From: Gerry Houlder, Seagate Technology <gerry.houlder@seagate.com>
Subj: SAS-2.1: Add low power transceiver options
Date: Oct. 27, 2008

SAS-2+ Changes (based on SAS-2 rev.14f):

Figure new1 – SAS transition to power management

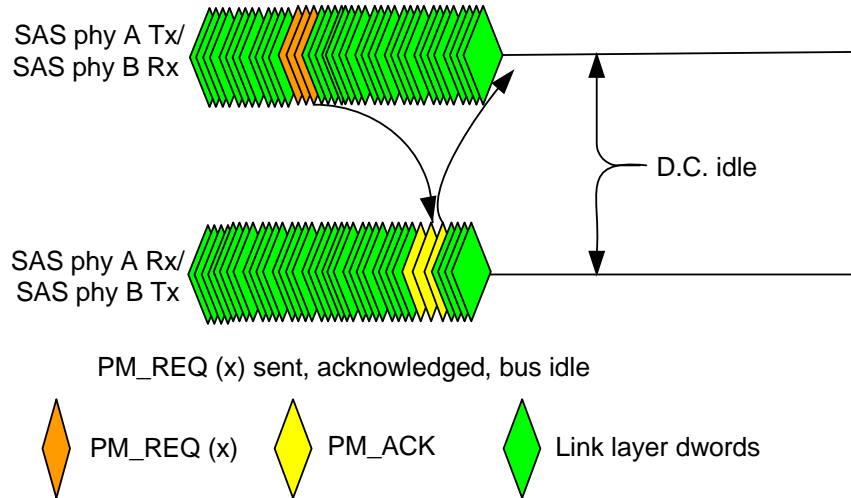
Figure new1 shows the sequence to transition from active to power management condition.

Figure new1 shows a transition from both ends sending link layer dwords to D.C. idle. The sequence proceeds as follows:

- 1) phy A sends PM_REQ(x) primitive to phy B;
- 2) phy B sends PM_ACK primitive to phy A;
- 3) both phys remember speed, training settings, SSC setting, and multiplexing setting; and
- 4) both phys transition to the requested D.C. idle condition.

Figure new2 – SAS COMWAKE wakeup sequence

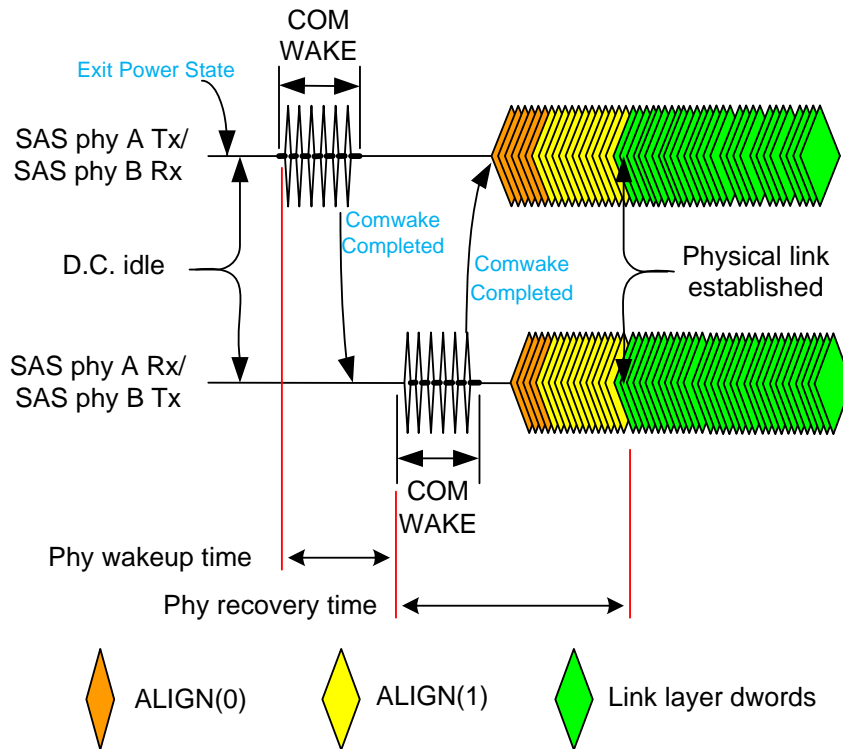
The sequence to recover from either partial or slumber power management condition is shown in figure new2.

The COMWAKE recovery sequence is as follows:

- 1) phy A initiates exit power management action by transitioning to active condition;
- 2) phy A transmits COMWAKE;
- 3) phy B detects COMWAKE, initiates exit power management action and transmits COMWAKE back to phy A;
- 4) both phys transmit ALIGN(0) primitives at previously negotiated settings;
- 5) when each receiver synchronizes on ALIGN(0)s, that transmitter changes to sending ALIGN(1)s;
- 6) when each receiver synchronizes on ALIGN(1)s, that transmitter changes to link layer dwords; and
- 7) if phys are multiplexed, the link layer sends the multiplexing sequence (see 6.7.4.3) to align the logical links.

The link is now re-established with the same transfer rate and SNW3 settings (e.g., SSC mode and multiplexing mode) that were negotiated before the link was placed in power management condition.

Figure new3 – COMWAKE hot-plug examples

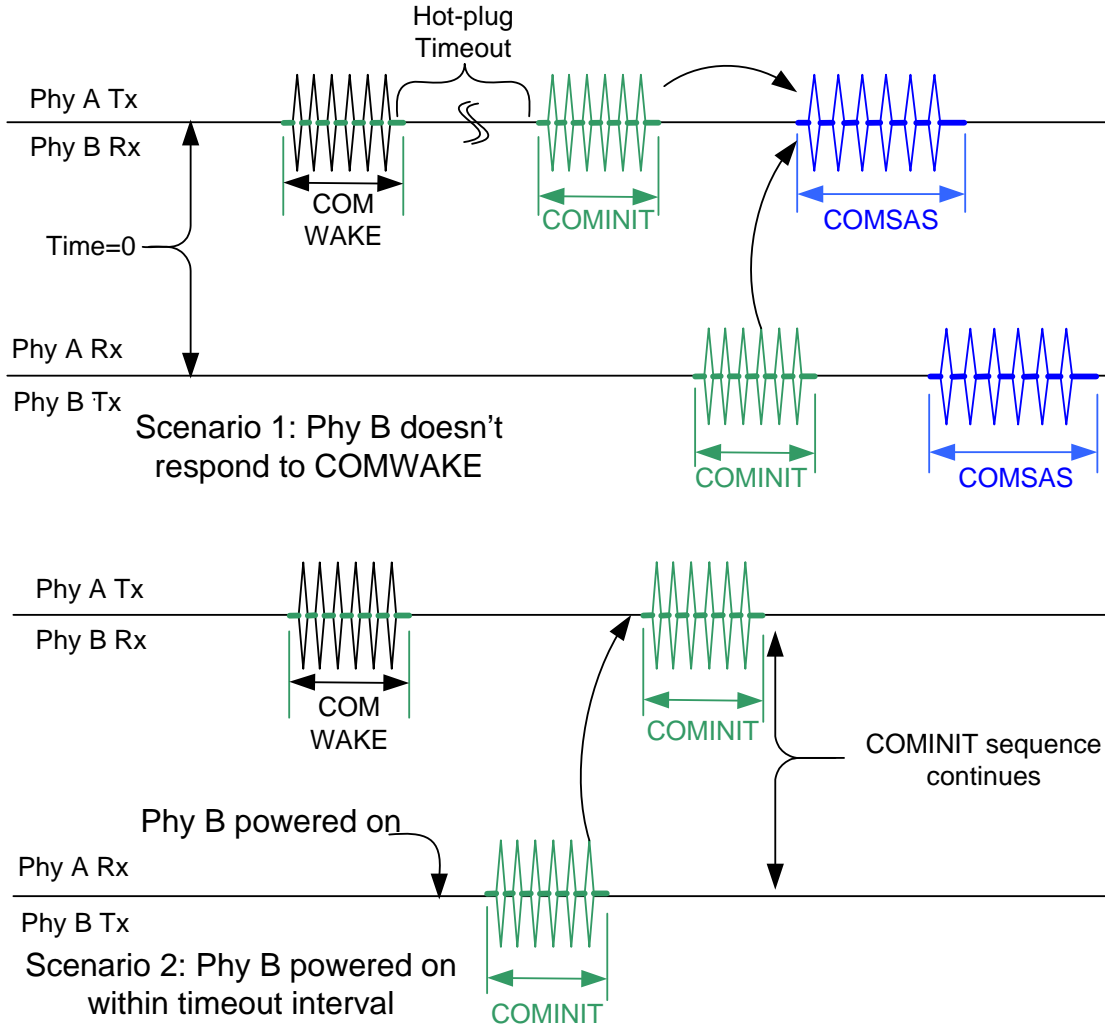
Figure new3 shows examples of hot-plug scenarios that may occur during power management recovery.

Scenario 1 depicts:

- 1) [phy A starting a power management exit request;](#)
- 2) [phy B target doesn't respond within timeout limit; and](#)
- 3) [phy A recovers by changing to COMINIT sequence.](#)

Scenario 2 depicts:

- 1) [phy A starting a power management exit request;](#)
- 2) [phy B is powered on and begins COMINIT sequence within the timeout limit; and](#)
- 3) [phy A proceeds by continuing the COMINIT sequence.](#)
